Re: NORI EIS Official Comment Form

NORI EIS Official Comment Form

NORI Collector Test Environmental Impact Statement (EIS) OFFICIAL PUBLIC COMMENT FORM

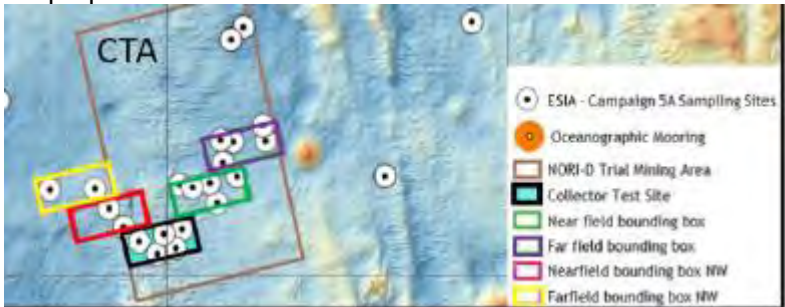
Page 4-9 4.5.1.1 – Table 4-8	This table talks about significance scores allocated to impacts. The Negligible definition indicates “Very high probability that the impacted VEC is well represented throughout the CCZ”. Here again, the absence of biological data means that any statement about representative probabilities is completely unsupported, given there is no evidence in the EIS of any of the biological VECs in the NORI area. If the “level of detail [required to characterize key environmental attributes] is not available for the collector test as the baseline studies are not yet complete, and there remains a degree of uncertainty around the sensitivity of many of the VECs” then potential impacts cannot be properly assessed.
